Access Compliance Report
Public Rights-of-Way
(Curb Ramps)

Intersection ID: 29240	Main Street: MALLARD_FOREST_DR	Cross Street: TRIMBACH_WY	Location: SE
ADA ID: BB351471AC0C	Ramp Type: PerpDiag	Initial Pass/Fail: Fail	Overall Compliance: No Severity Score: 13.75

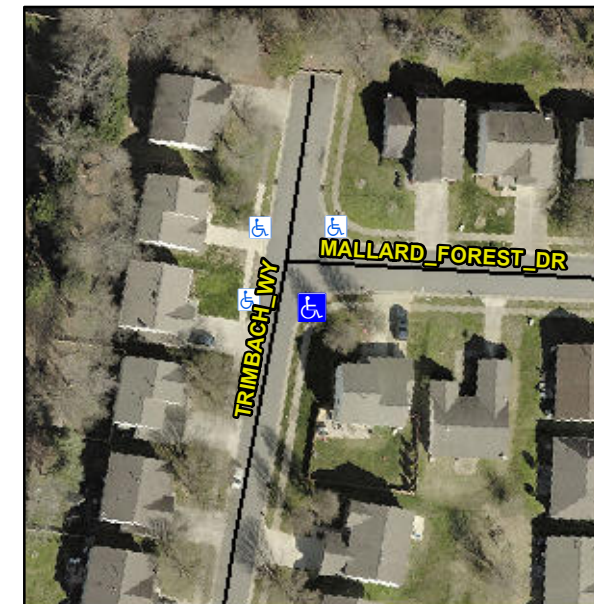
Not Found, R304.2.2, R304.5.3

Compliance	Description	Data	Compliance	Description	Data
N/A	Ramp Length (in)	43.5	No	Ramp Slope (%)	10.5
Yes	Ramp Width (in)	55.0	No	Ramp XSlope (%)	2.4
N/A	Flare Type LT	N/A	N/A	Flare Type RT	N/A
N/A	Flare Slope LT (%)	N/A	N/A	Flare Slope RT (%)	N/A
N/A	Flare Traversable LT?	N/A	N/A	Flare Traversable RT?	N/A
N/A	Landing Length (in)	N/A	N/A	DWS Provided?	N/A
N/A	Landing Width (in)	N/A	N/A	DWS Contrast?	N/A
N/A	Landing Slope (%)	N/A	N/A	DWS Length (in)	N/A
N/A	Landing X Slope (%)	N/A	N/A	DWS Full Width?	N/A
N/A	Landing Curb? (Y/N)	N/A	N/A	DWS Offset (in)	N/A
N/A	Shared Landing?	N/A			
N/A	Gutter Ponding?	N/A	N/A	Gutter Slope (%)	N/A
N/A	Gutter Lip Ht (in)	N/A	N/A	Gutter X Slope (%)	N/A
N/A	Painted X Walk1?	No	N/A	Painted X Walk2?	No
	X Walk 1 Direction	To NE		X Walk 2 Direction	To W
N/A	X Walk 1 Width (in)	N/A	N/A	X Walk 2 Width (in)	N/A
	X Walk 1 Slope (%)	2.4		X Walk 2 Slope (%)	1.8
	X Walk 1 X Slope (%)	0.1		X Walk 2 X Slope (%)	0.7

Remove & Replace Curb Ramp With Two New Directional Ramps or Equivalent.
